ADDENDUM NUMBER 1

Wednesday, April 11, 2018

**PROJECT:**  
FAIRHOPE LIBRARY ENVELOPE REPAIRS  
FAIRHOPE, ALABAMA  
GMC PROJECT NO. AMOB170026

### MODEL H75 — 75° Ships Ladder

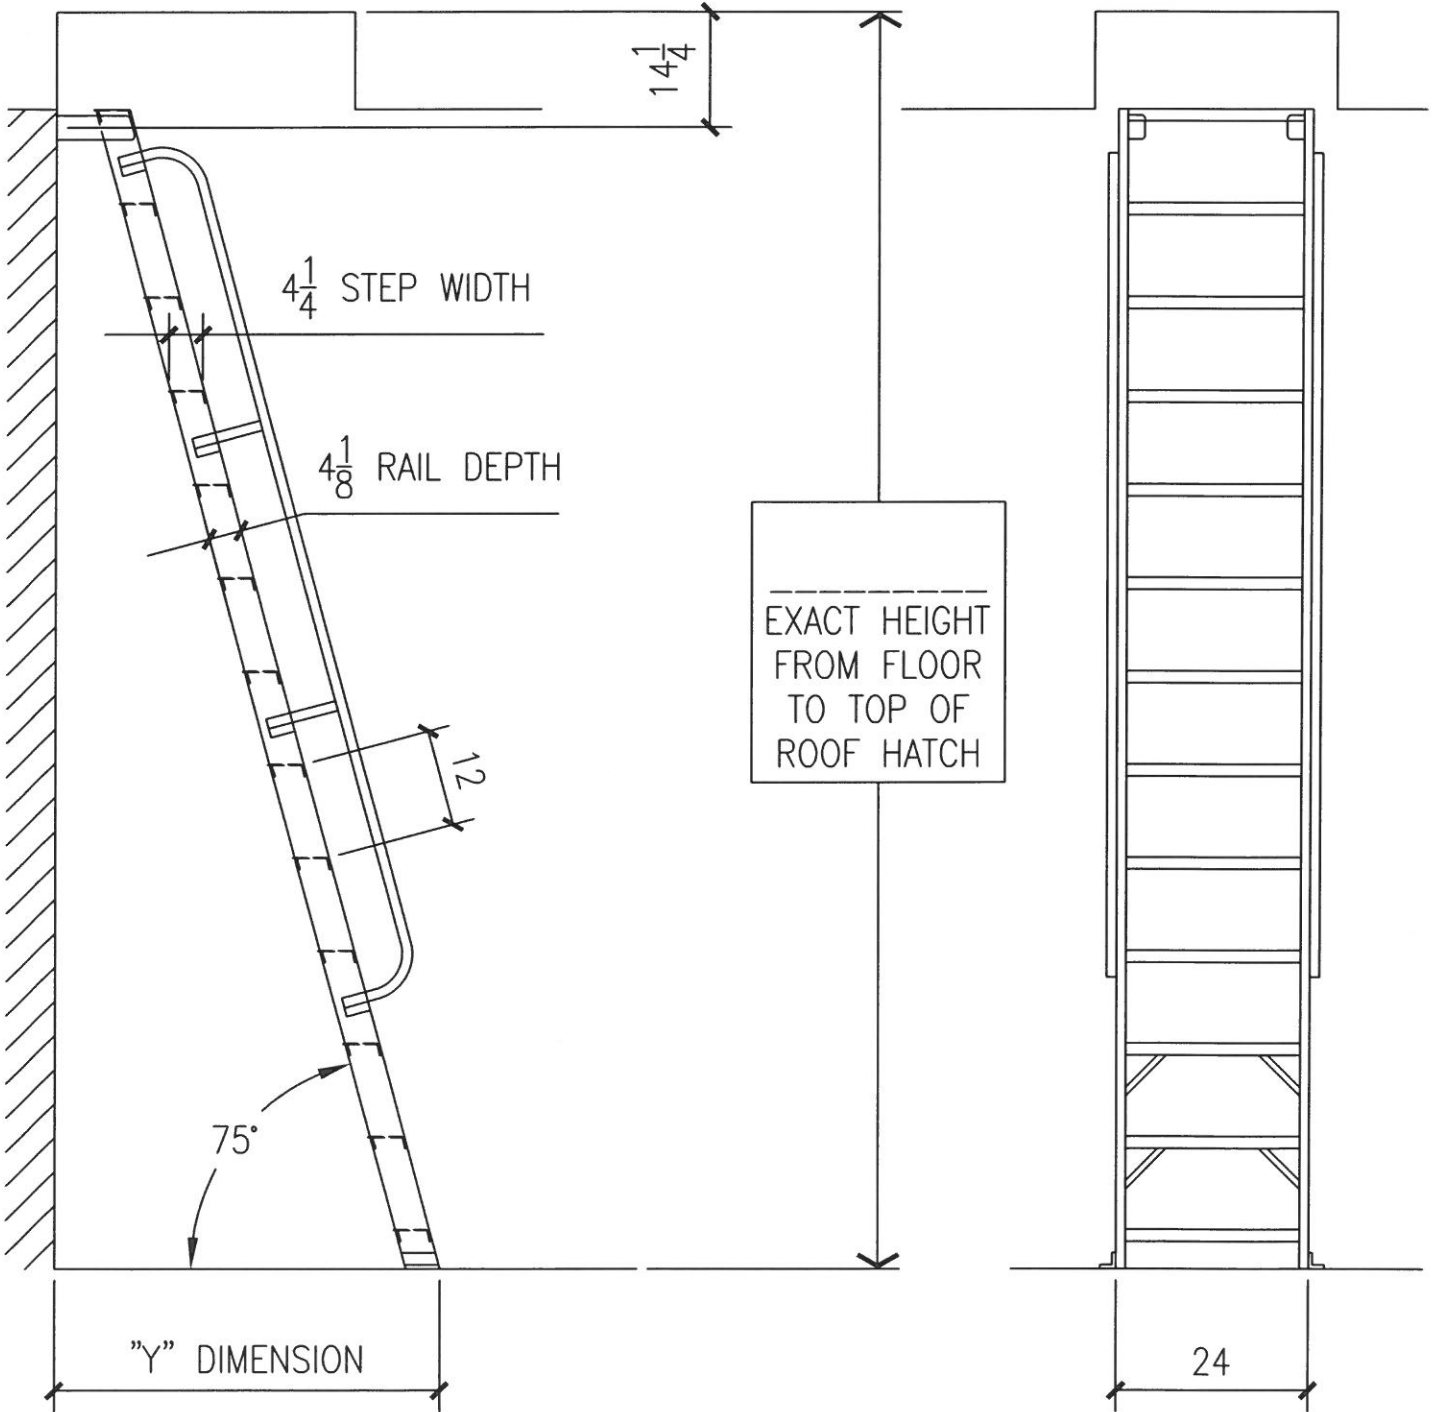
- A. Provide and install a new ships ladder to attach to the existing roof hatch. Contractor shall verify floor to floor height for ladder, but for bidding purposes provide a height of +/- 13'-6" floor to top of roof hatch ladder. Provide Alaco Ladder Company or approved equal. See attached ladder cut sheet and Specification Section 05511. Contractor to field verify opening for adequate ladder attachment. Provide additional steel framing if required for ladder attachment.

- B. ALACO ships ladders or approved equal are designed for access to roof hatches, mezzanines, equipment lofts and other restricted spaces, with heavy duty aluminum top and bottom brackets for a fixed, permanent installation.
- C. Model H75 (370-75) or approved equal ladder is designed for use with roof hatches.
- D. Ladder and components are fabricated from 6061-T6 aluminum alloy. Model H75 (370-75) ships ladders feature 4-1/4" (108 mm) wide steps with nonslip ridges mounted on 12" (305 mm) centers. These 24" (610 mm) wide ladders are equipped with 4 mounting brackets. Flush handrails consist on 1-1/4" (32 mm) round serrated aluminum tubing with cast aluminum fittings.
